Access Compliance Report

Public Rights-of-Way

(Curb Ramps)

Intersection ID: 4652	Main Street: W_SUGAR_CREEK_RD	Cross Street: HUBBARD_RD	Location: SE
ADA ID: 821AD03B63F4	Ramp Type: Perp	Initial Pass/Fail: Pass	Overall Compliance: No
Severity Score: 10			
Codes/Mitigation Info/Possible Solution		Field Measurements/Component Compliance

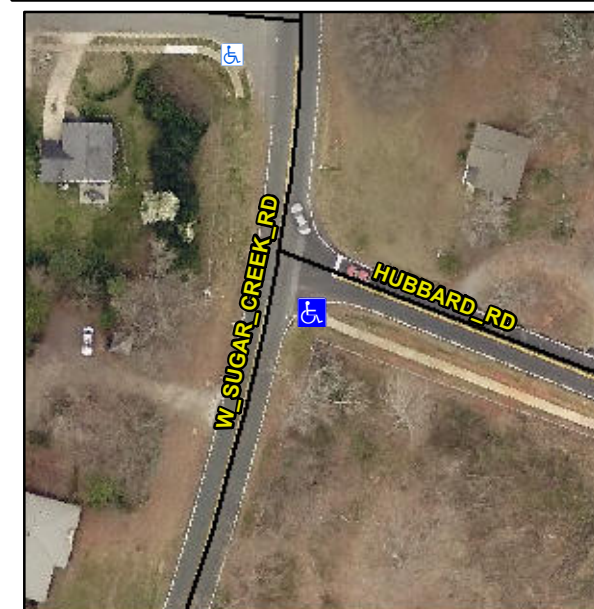
**Remove & Replace Entire Ramp.
Gutter Ponding Observed.**

**R304.2.1, R304.2.2-Perp, R304.3.2-
Para, R304.5.3, R305.2, R302.7**
